# Rezoning Transportation Analysis

Petition Number: 2019-045

## Revision Log:

Date	Description
04-21-2019	First Review

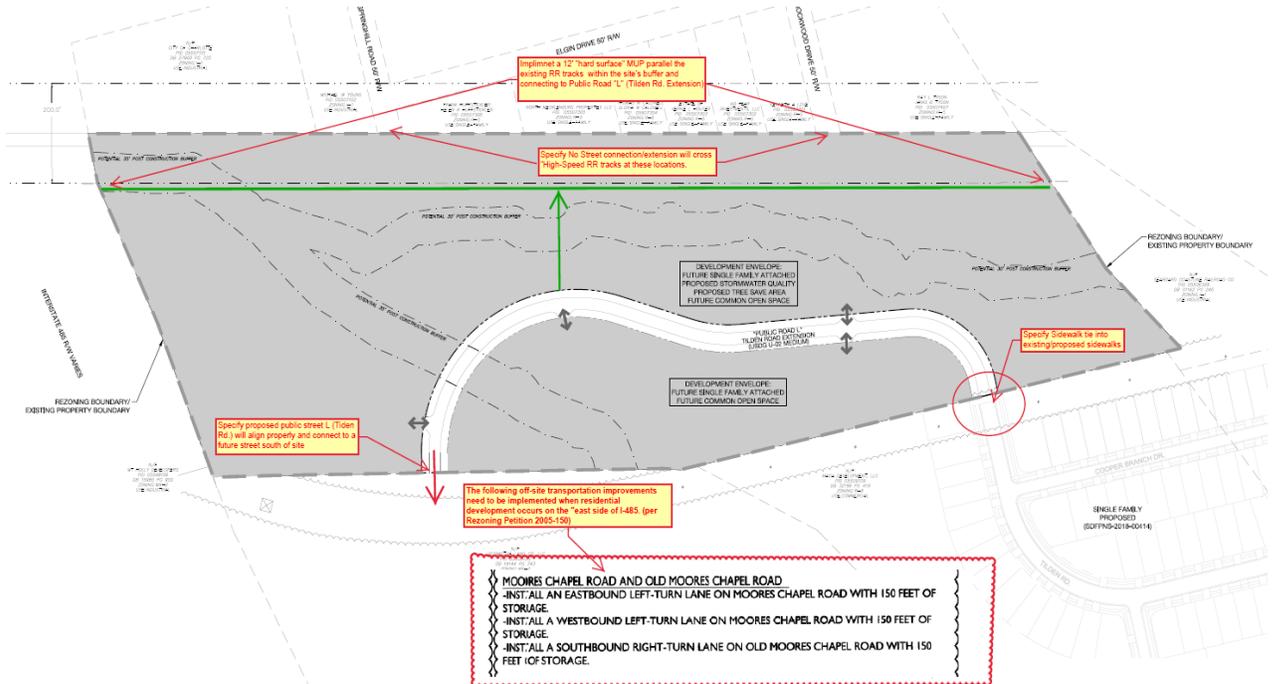
- The petitioner should revise the site plan and conditional note(s) to provide the following off-site transportation improvements at Moores Chapel Road and Old Moores Chapel Road as specified in Rezoning Petition 2005-150, when residential development occurs on the east side of I-485 (see below insert).
